Memorandum

To: Jerry Burgess, Park Engineer, Glacier National Park

From: Larry Martin, Hydrogeologist, Water Resources Division

Subject: Proposed well at Polebridge Entrance Station

Schematic West-East Hydrogeologic Cross-Section Through the Polebridge Area

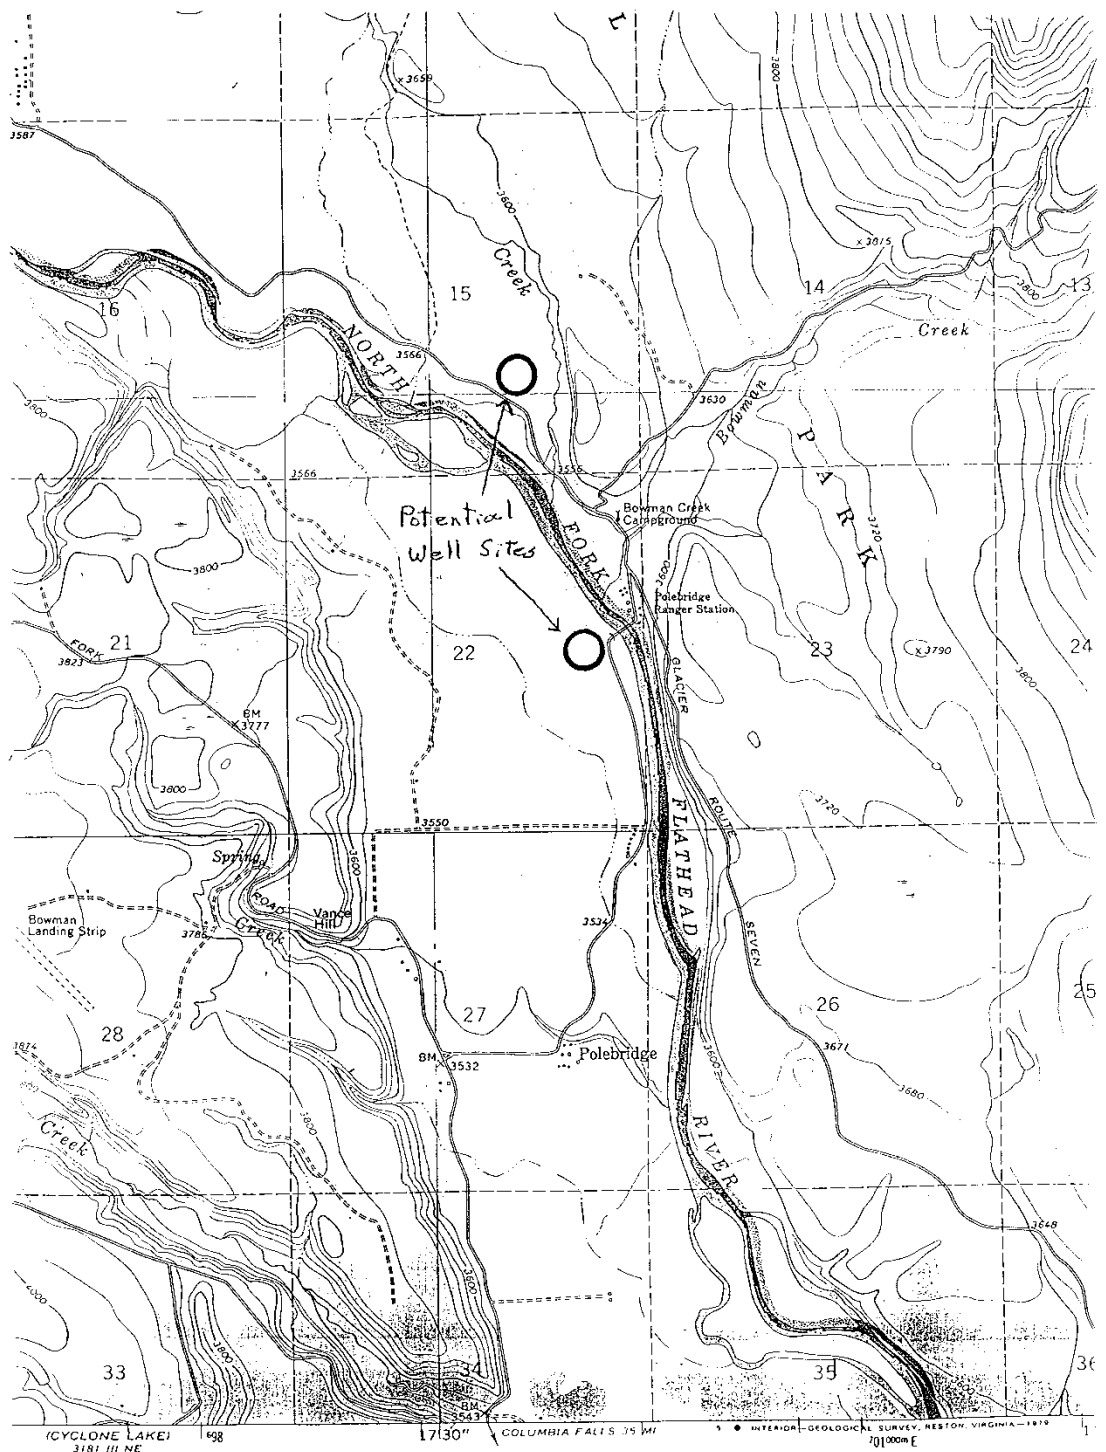
A schematic west-east geologic cross-section through the Polebridge area is attached to this report to help the reader understand the hydrogeologic conditions.

Locations of previously drilled dry test holes and potential sites for well construction where the hydrogeology is favorable for successful well construction. Locations to the east of the dashed red line are not likely to result in successful well construction.

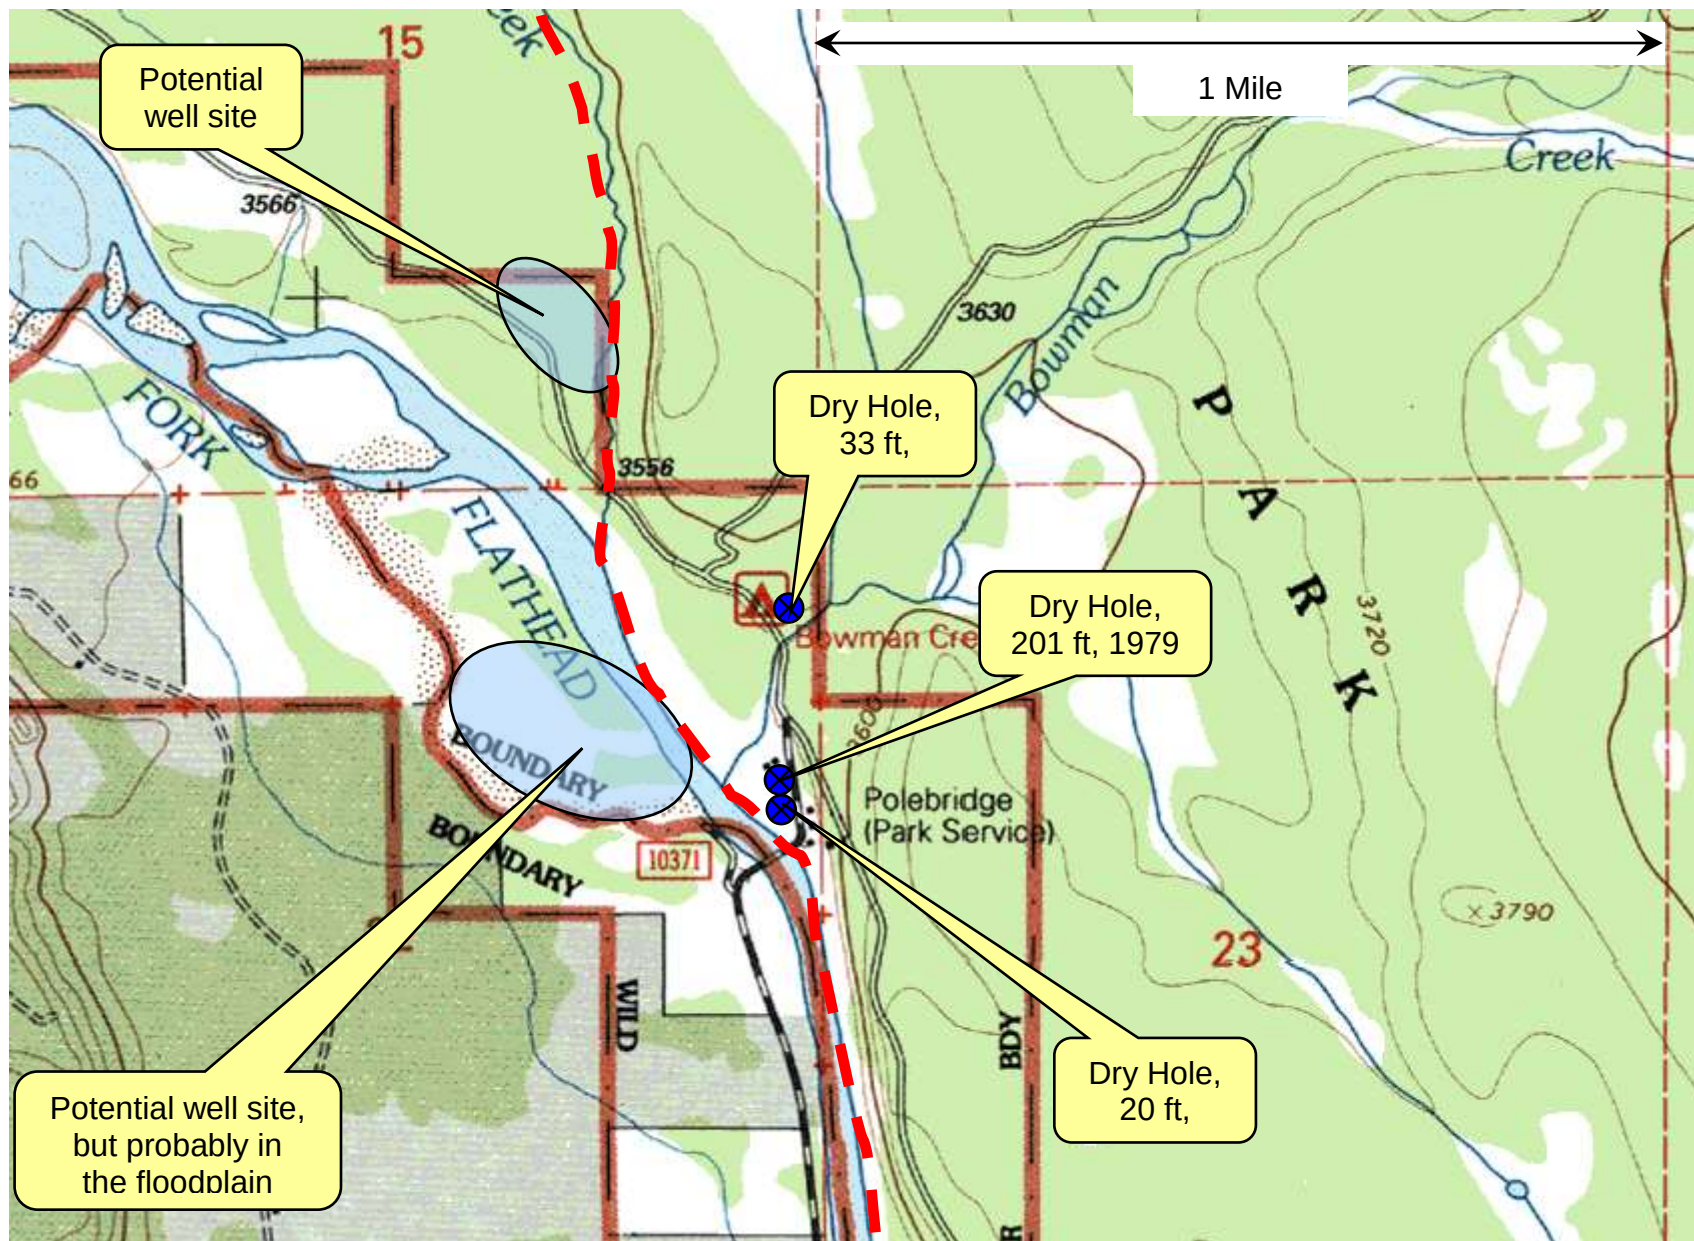
Standard wells could be constructed in the alluvium of the North Fork. The nearest locations to construct wells are across the bridge on the west side of the river or about ½ mile north of the entrance station where the valley broadens on the east side of the river. A well in either of these locations would need to be drilled to about 50 feet and could be expected to yield 20-50 gpm. Well locations could be picked to insure that the wells would be considered to be true groundwater sources by Montana DEQ (rather than groundwater under the direct influence of surface water). Such a determination would preclude the necessity for filtration. A map showing these locations is attached.
